Re: **Guilford Court - Wayne Barker**
157 York Street
Portland, ME

To: Mark Chaloupecky
From: Mike Nugent/Manager of Inspection Services
Date: 08/18/2004
Re: 157 York St. (044 B005)

To: Mark/Port City Architects
From: Mike Nugent/Manager of Inspection Services
Date: 07/27/2004
Re: 157 York St. (044 B005)

TO: Mark Chaloubecky **From:** Mike Nugent
Fax: 761-2010 **Date:** August 23,2004
Phone: 761-9000 **Pages:** 1
Re: 157 York St.

WIJ-1.2 One Hour Fire-Resistive Ceiling Assembly

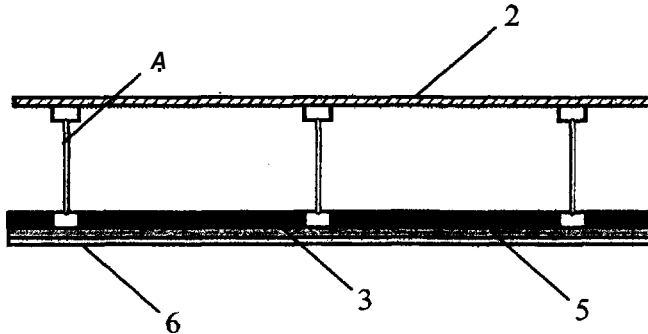
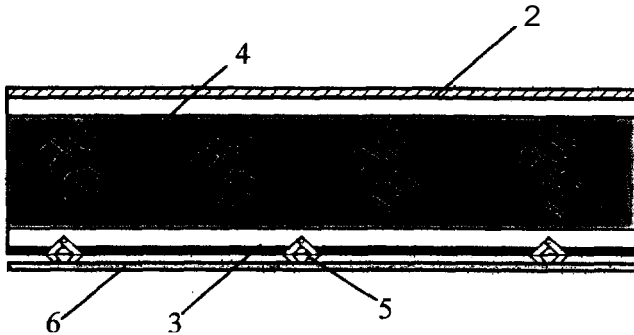
2. Per BOCA Table 302.1 - the entire basement floor is considered a storage area in excess of 100s.f.. The basement floor is being sprinkled along with the rest of the building per BOCA Section 904.9 and 906.2.2. The basement floor is separated from the rest of the building by a 1-hour rated floor/ceiling assembly as shown on Sheet A-10 (see attached). It is also separated from the stair towers with a one-hour rated assembly as shown on Sheet A-1 (wall type 1A, Sheet A-2).

- 7) What is the sound transmission class of the Dwelling Unit separations walls
- 8) Please provide a floor ceiling assembly detail w/ fire resistance rating, sound transmission class and UL listing.

1. **Floor Topping (optional, not shown):** Gypsum concrete, lightweight or normal concrete topping.
2. **Floor Sheathing:** Minimum **23/32"** thick tongue-and-groove wood sheathing (Exposure I). Installed per code requirements with minimum 8d common nails and glued to joist top flanges with AFG-01 construction adhesive.

3. **Insulation:** Minimum 1-1/2" thick mineral fiber insulation batts – 2.5 pcf (nominal), supported by resilient channels.
4. **Structural Members:** Wood I-joists spaced a maximum of 24" on center.
 Minimum I-joist flange depth: 1-1/2" Minimum I-joist flange area: 5.25"²
 Minimum I-joist web thickness: 7/16" Minimum I-joist depth: 9-1/4"

5. **Resilient Channels:** Minimum **0.019"** thick galvanized steel resilient channels, attached perpendicular to I-joists using 1-5/8" long drywall screws. Resilient channels spaced 16" on center and doubled at each wallboard endjoist extending to the next joist.

6. **Gypsum Wallboard:** Minimum **5/8"** thick Type C gypsum wallboard installed with long dimension perpendicular to resilient channels and fastened to each channel with minimum 1" long Type S drywall screws. Fasteners spaced 12" on center in the field of the wallboard, 8" on center at wallboard end joints, and 3/4" from panel edges and ends. Endjoints of wallboard staggered.
